subject Hamilton Wetlands Post-Construction As-Built Survey Review – Breach and Completion Contract.

This memorandum presents the ESA's post-construction assessment of the Hamilton Wetland Restoration Project following the Breach and Completion Contract.

As-Built Survey Data - Outboard Levee Breach
Cross Sections 2

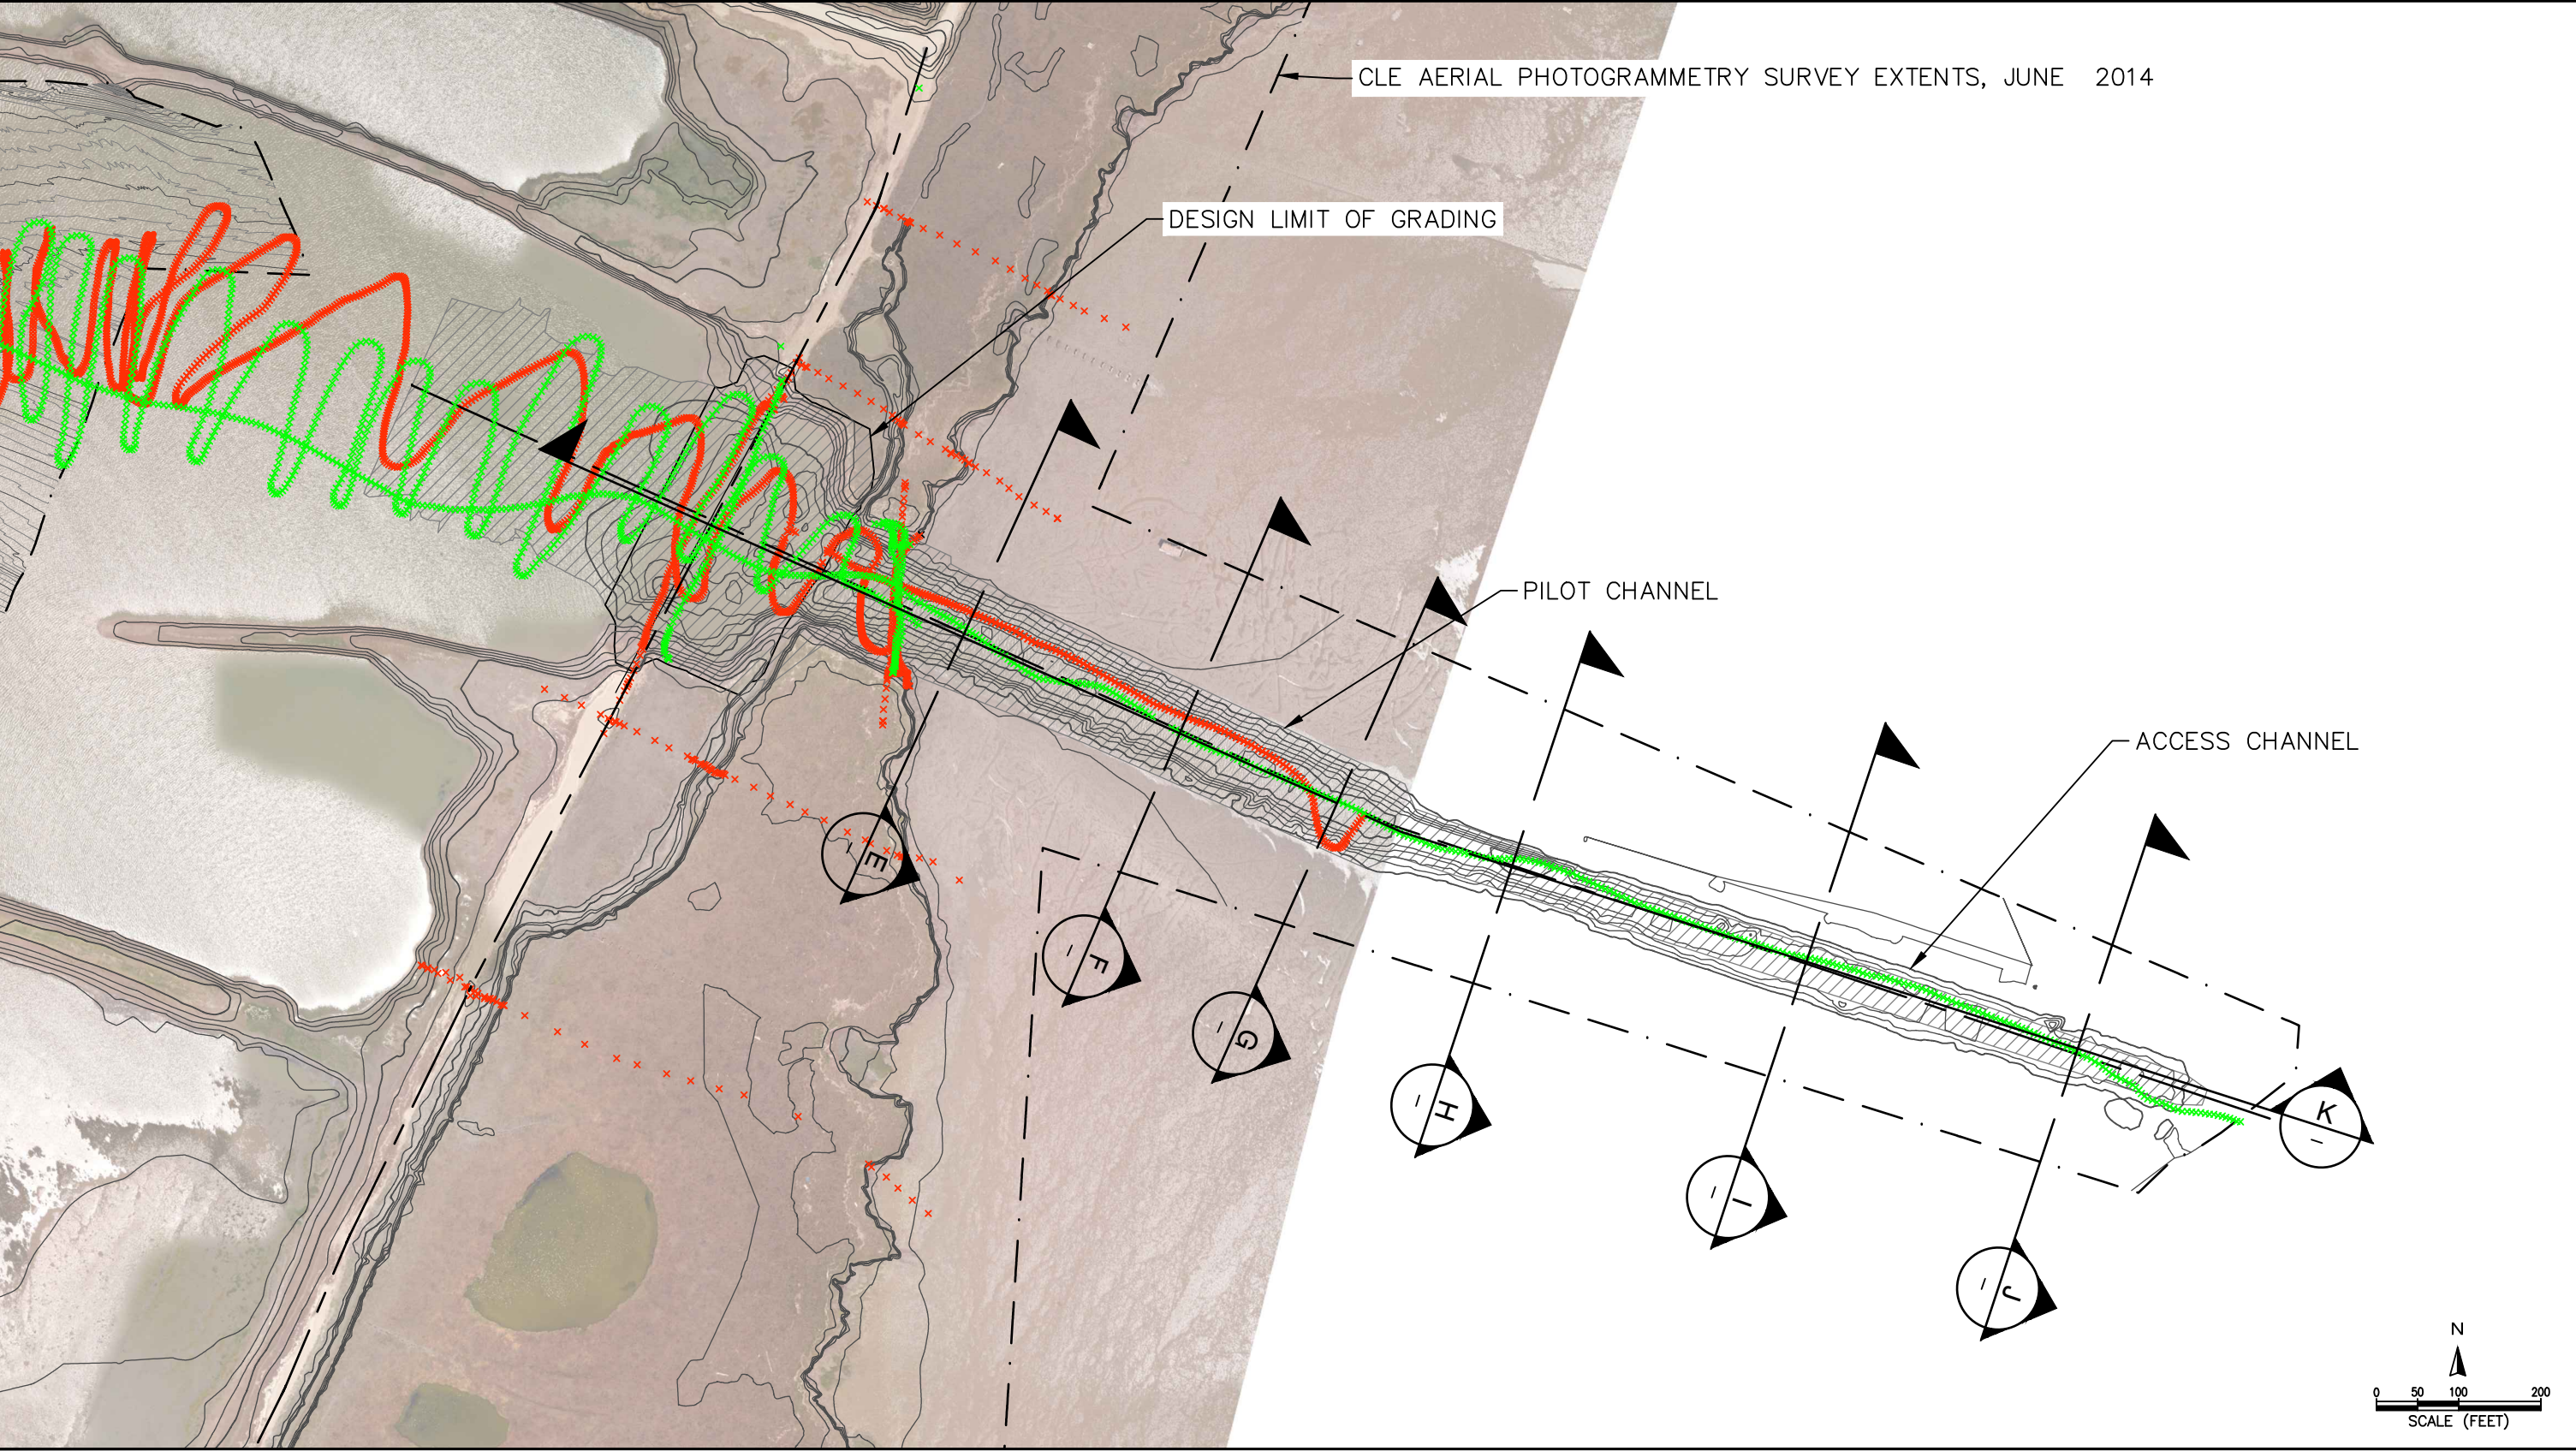
Figure 22 also shows the design limit of grading for the breach channel. The figure shows where the as-built grading does not extend to the limits of grading specified in the design. Specifically, the transition between the breach to the pilot channel was constructed ~40 ft inboard of the station specified in the design. This reduced excavation footprint resulted in a reduced channel width at Section C (Figure 24), with a constructed base width of about 110' vs. the 210' design width.

- Monitoring of the Outboard Levee Breach is expected to confirm that breach is expanding and confirm hydrology improvement via review of water level data. If monitoring indicates that tidal hydrology is not acceptable, consider excavation to expand breach.

Hamilton Post-Construction Assessment
FIGURE 29
 Outboard Levee Plan View

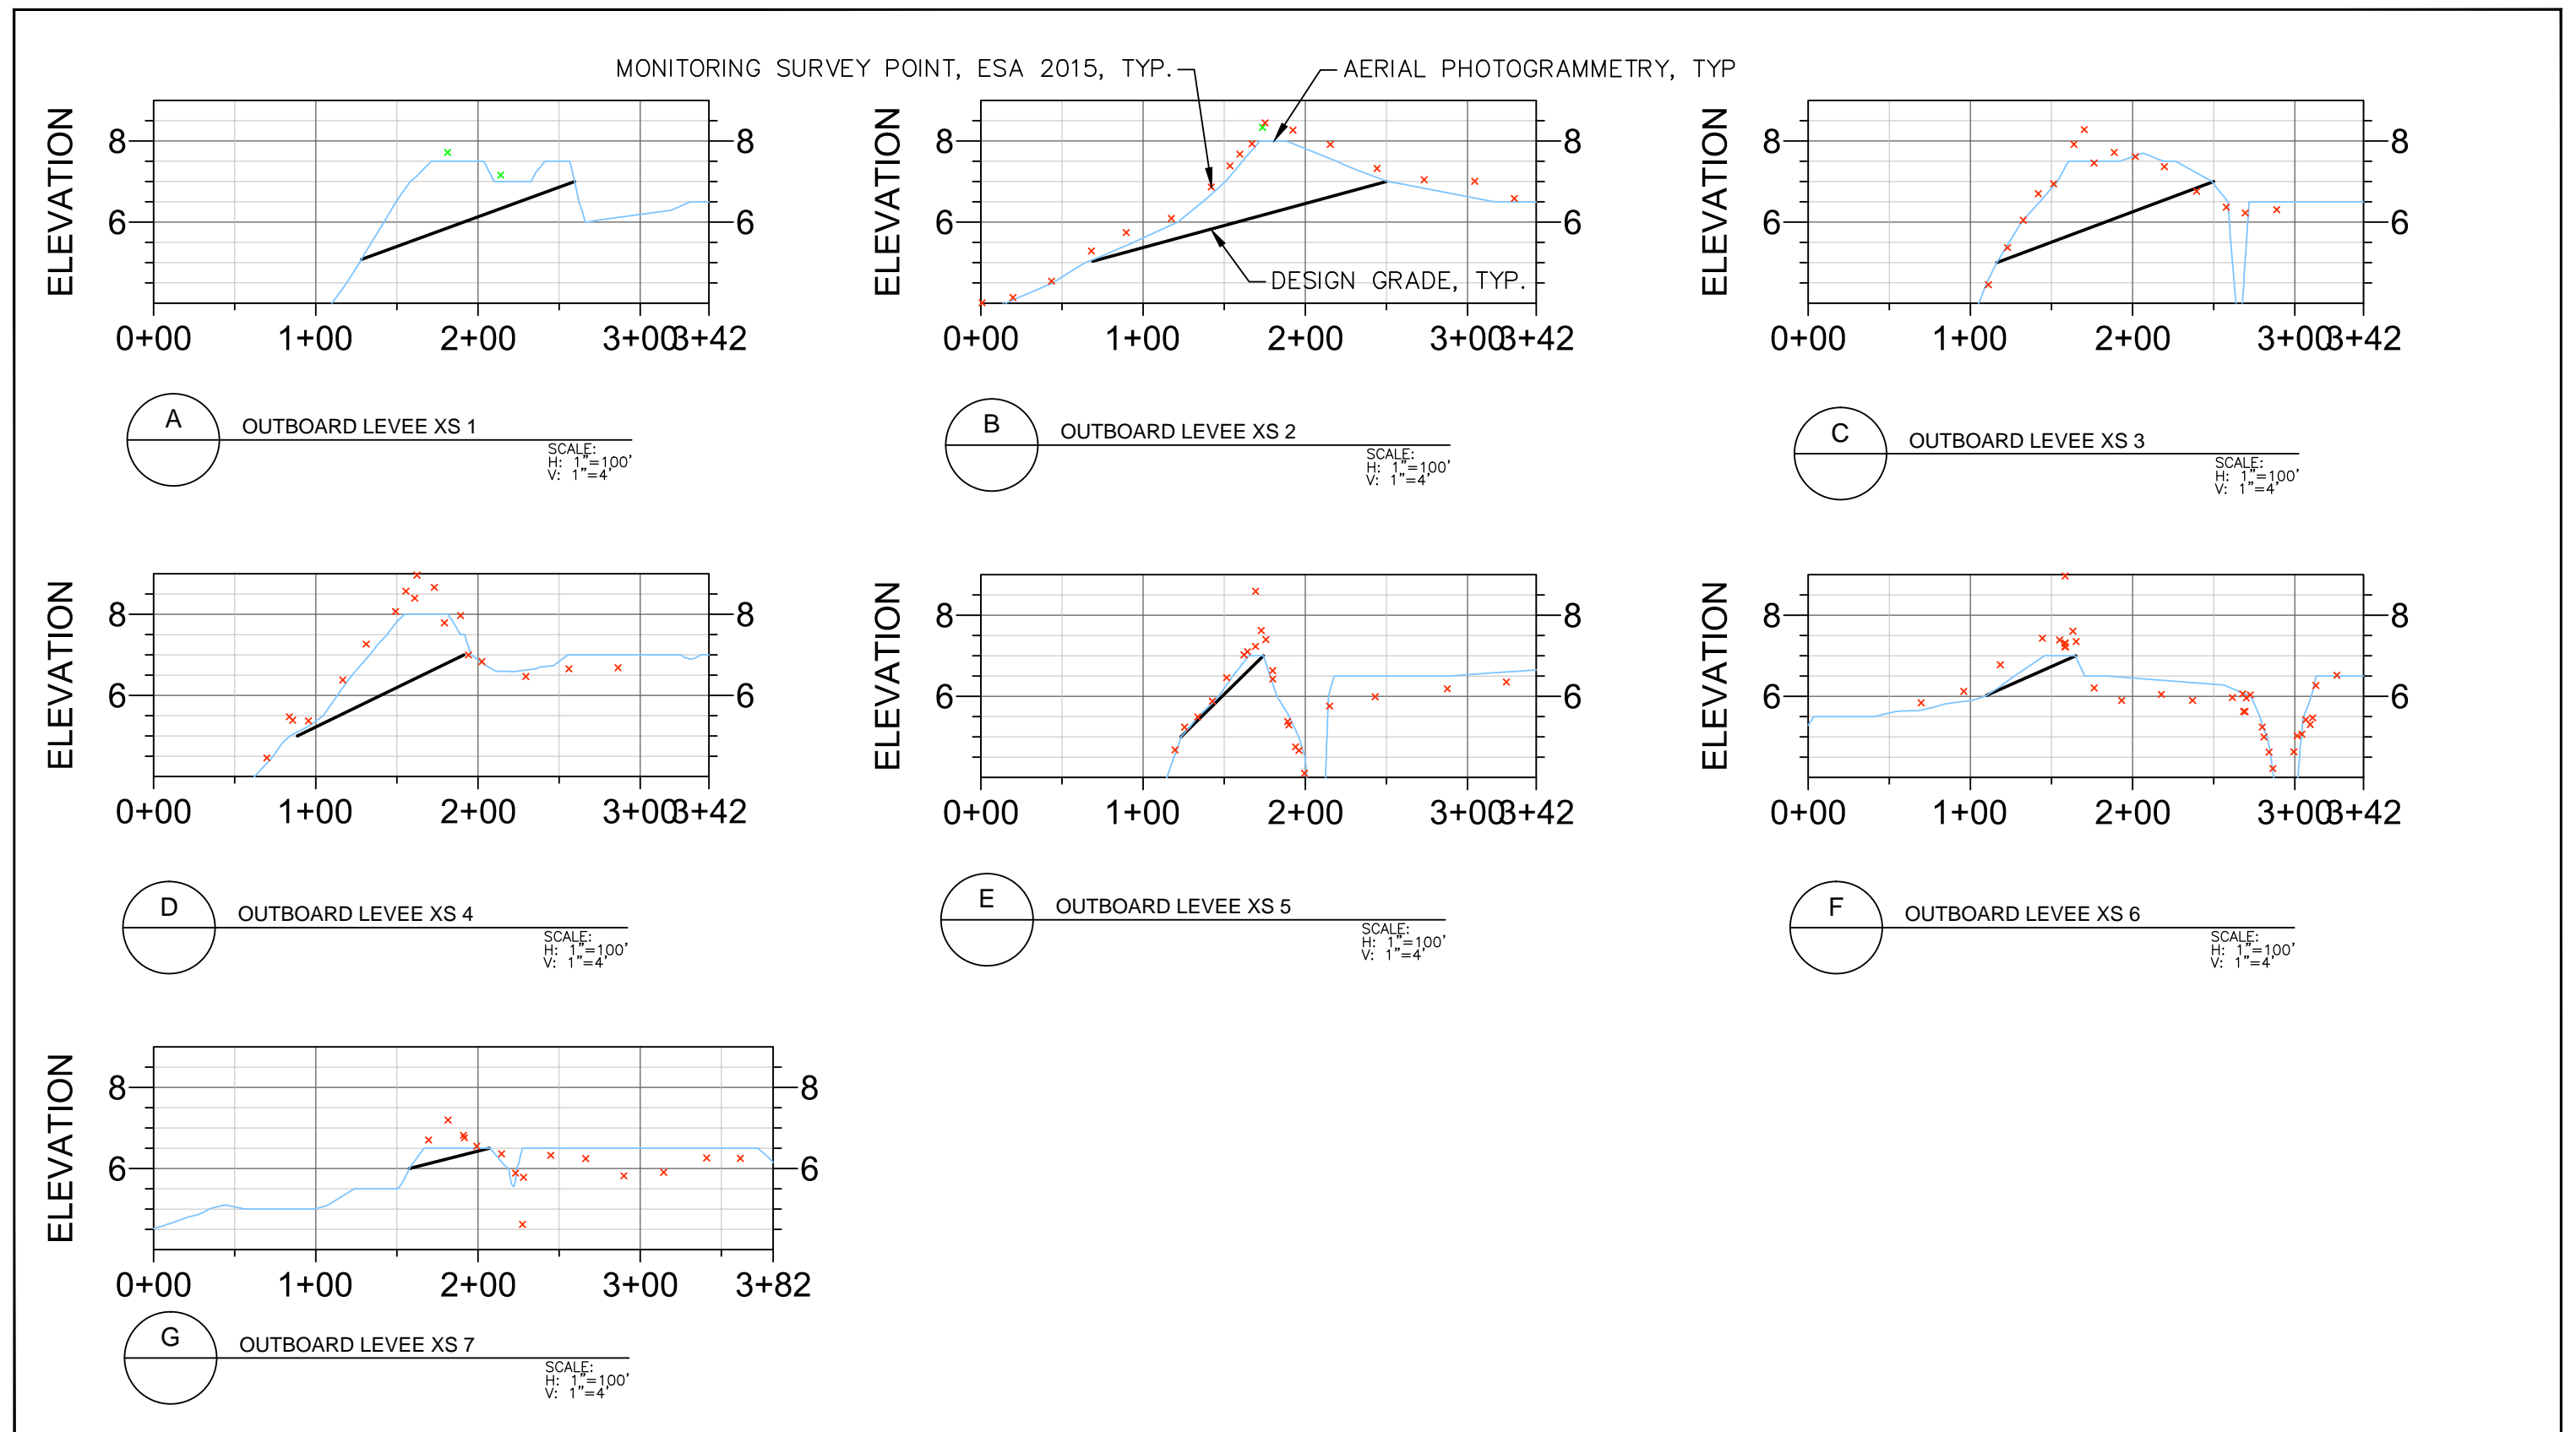
The outboard levee separates the restored project area from the existing bayfront marsh. This levee was to be lowered to provide a smooth transition between the inboard and outboard marshes. The design grade of this feature sloped from ~EL 7.0 ft (@ limit of native marsh vegetation) along the outboard marsh to EL 5.1 ft at the inboard side of the levee. The as-built crest elevation was found to be considerably higher than the design grade, reaching elevations up to 8.72 ft, and consistently exceeding EL 8.0 ft for long stretches. Figure 29 shows a plan

view of the outboard levee, including the location of spot elevations collected by ESA. Figure 30 shows several cross sections cut along the length of the outboard levee, showing as-built grades captured by the aerial photogrammetry as well as the design grade. Figure 31 shows a profile along the centerline of the outboard levee, showing as-built grades captured by the aerial photogrammetry, as well as high points captured in the ESA monitoring survey. This figure also highlights the EL 7.0 ft, the maximum allowed elevation of the lowered levee.

- Lower the outboard levee to design grades including the clean clay soil cap as required by the contract.
 - If lowering the outboard levee is not practicable, native plantings appropriate for high marsh and transitional zones (similar to those for the Wildlife Corridor) should be planted along the higher reaches of the outboard levee limit establishment of non-native vegetation including perennial pepperweed.
